STAFF RECOMMENDATION

109 Lindsley Park Drive

February 21, 2018

Application: New construction—addition; Partial demolition

2 1ST FLOOR DEMO PLAN
1/8" = 1'-0"

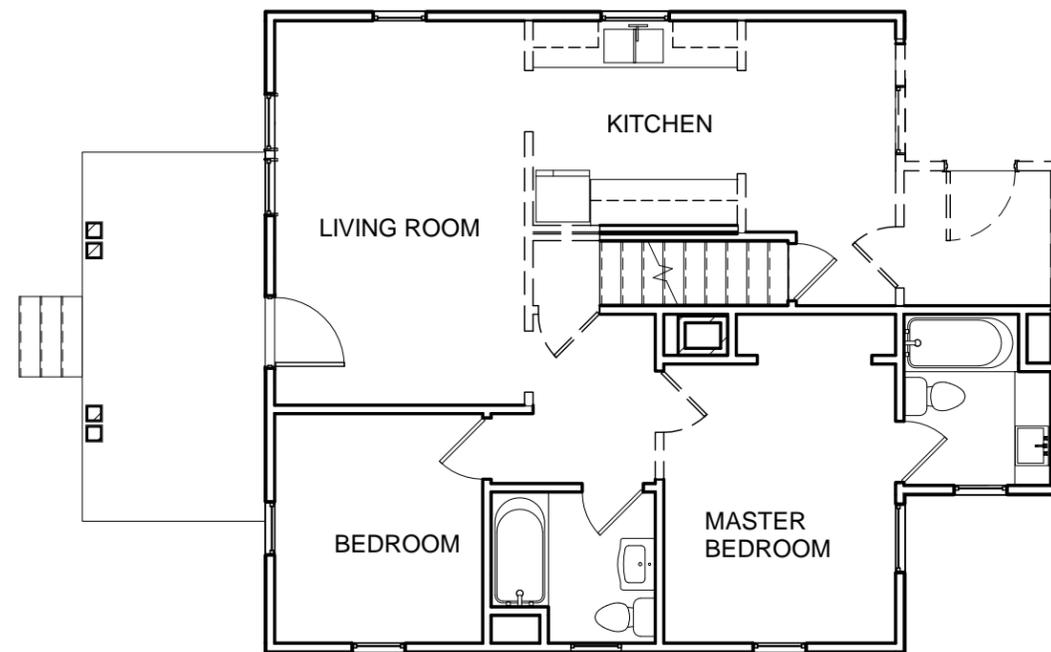
Partial Demolition: The applicant plans to demolish a portion of an existing rear addition in order to tie the new work into the existing house (Figure 2). A small section of the rear wall of the kitchen will be removed as well. The date of construction of the existing addition is not known; however, this area is not visible from the public right of way, is not architecturally significant and does not contribute to the character of the neighborhood. Staff therefore finds that the demolition and alteration of this small addition and section of rear wall meets Section III.B.2. of the guidelines for appropriate demolition and does not meet Section III.B.1. for inappropriate demolition.

ELEVATIONS

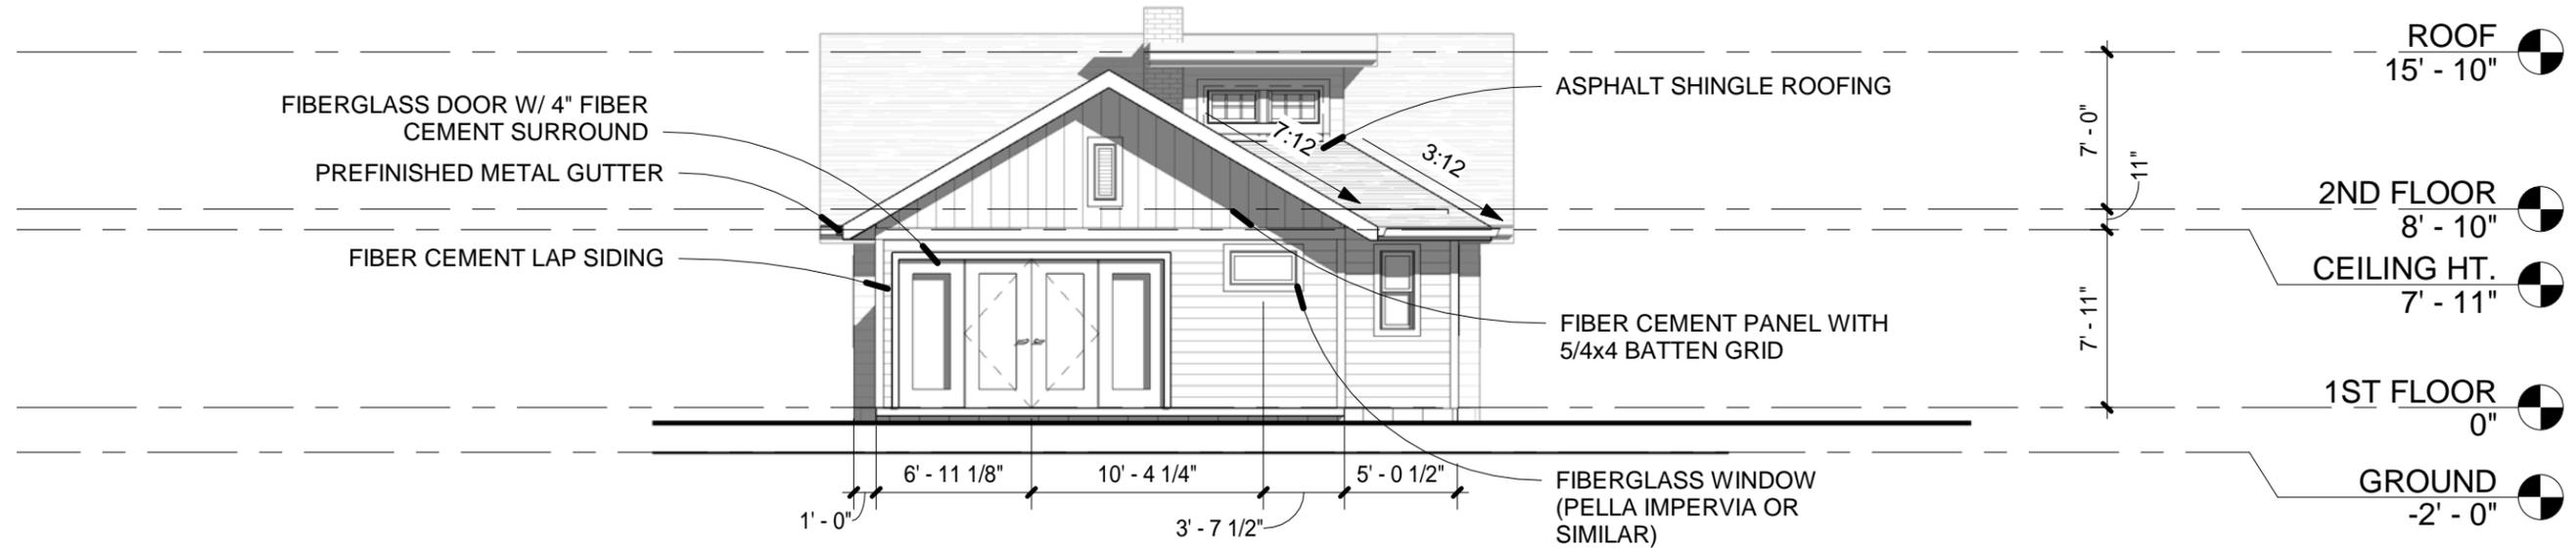
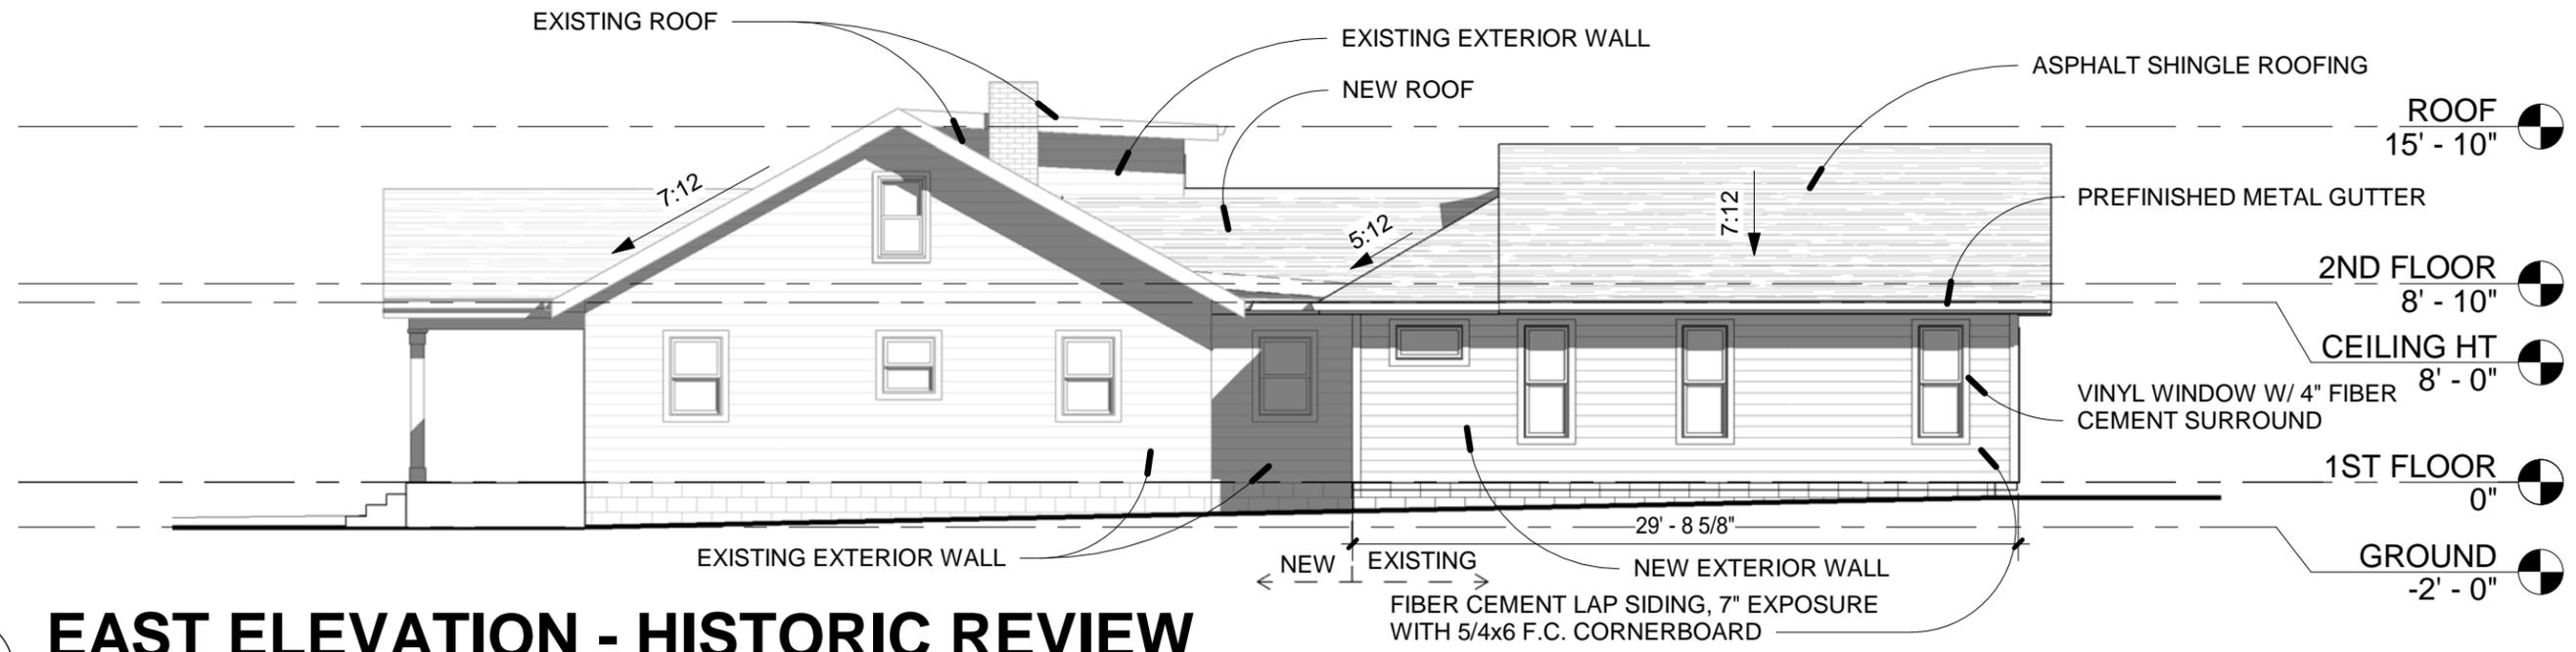
The plans indicate a seven inch (7") reveal for the siding, but the applicant has agreed to use a five inch (5" reveal). With this change and with Staff's final approval of all windows and doors, Staff finds that the addition meets Sections II.B.4. and II.B.10. of the design guidelines.

Proportion and Rhythm of Openings: The only change to existing windows on the house will occur on the rear elevation. One window on the ground level will be removed where the addition is being constructed. Additionally, in the rear-facing dormer, the windows will be shortened to accommodate the roof of the addition. The width will remain the same. Staff finds these changes to be appropriate, as they are occurring on a rear elevation. Most of the windows on the proposed addition are twice as tall as they are wide, thereby meeting the historic proportions of openings. There are two horizontal

1. The siding reveal shall be five inches (5").
2. Staff shall approve the final windows and doors prior to purchase and installation.

1 EAST ELEVATION - HISTORIC REVIEW
 1/8" = 1'-0"

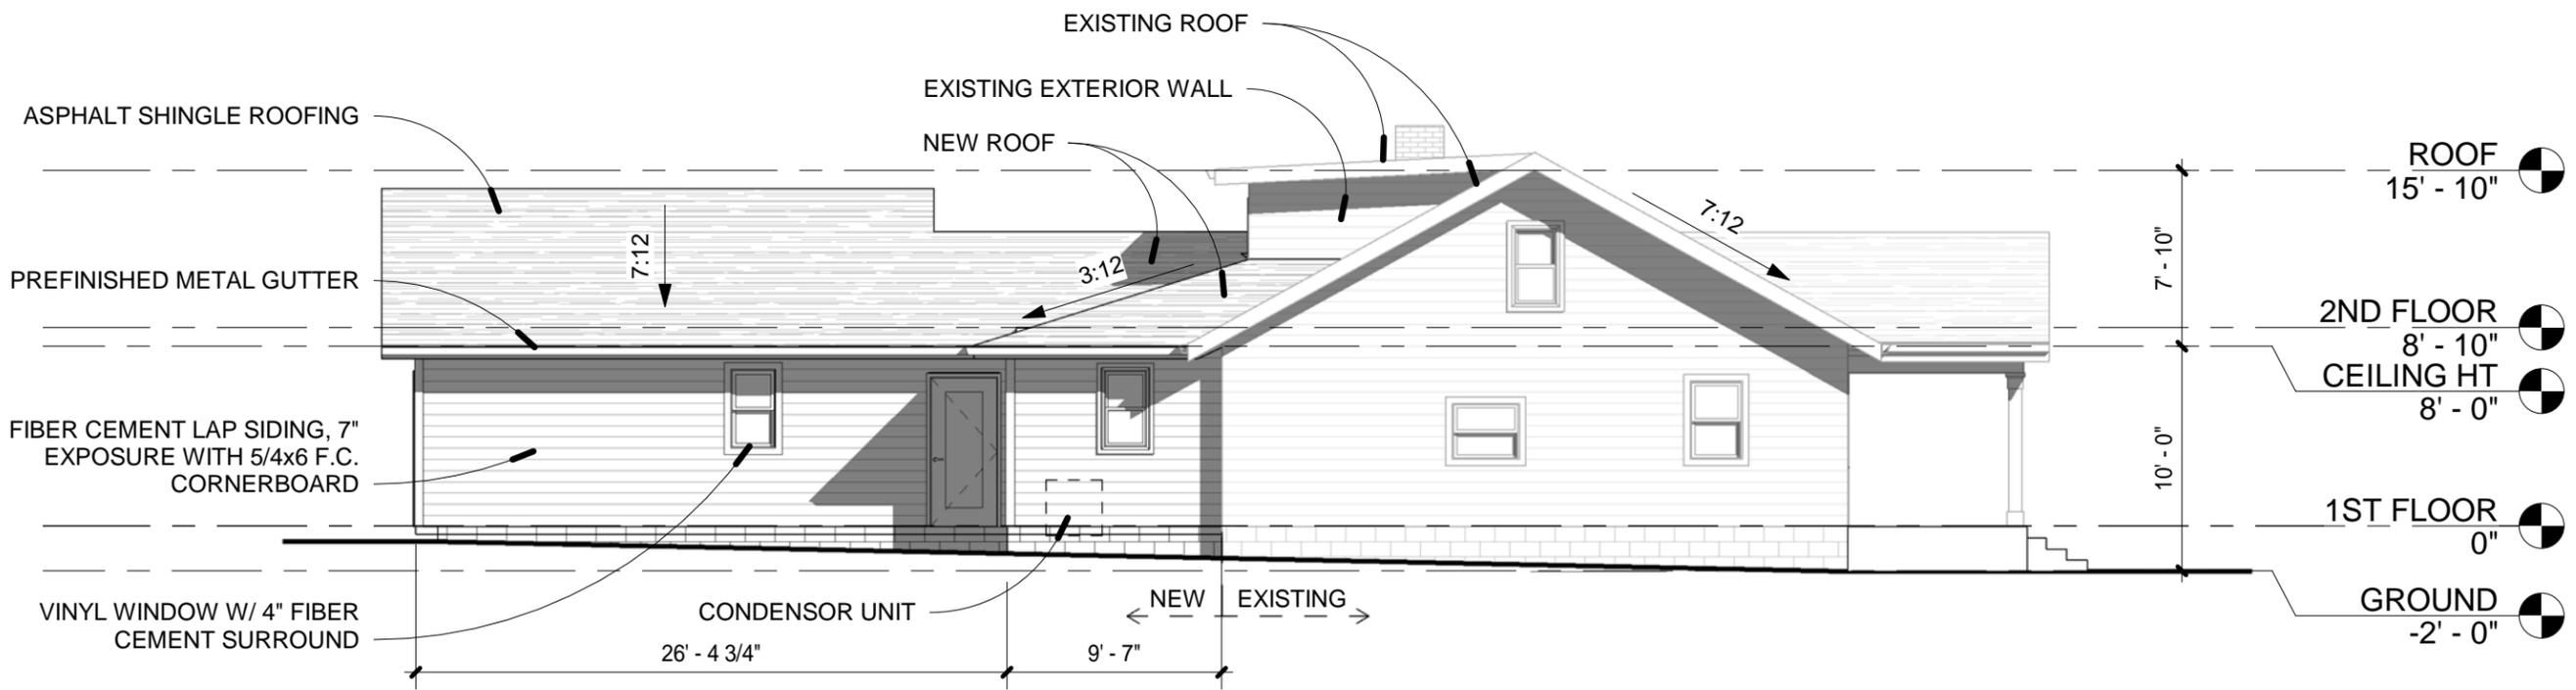
window openings, one on the east elevation and one on the rear. Staff finds these to be acceptable because the one on the rear will not be visible and the one on the east is well set back from the front of the house, and the wall is inset, such that the window will not be highly visible from the street. On the west elevation, there is one nearly thirteen foot (13') expanse of wall space without a window or door opening. Staff finds this to be acceptable, as it is a side wall and is fifty feet (50') back from the front wall of the house. Staff finds the project's proportion and rhythm of openings to meet Section II.B.7.

Appurtenances & Utilities: No changes to the site's appurtenances were indicated on the drawings. The location of the HVAC condenser unit is indicated along the west elevation, beyond the midpoint of the house. Staff finds this to be appropriate.
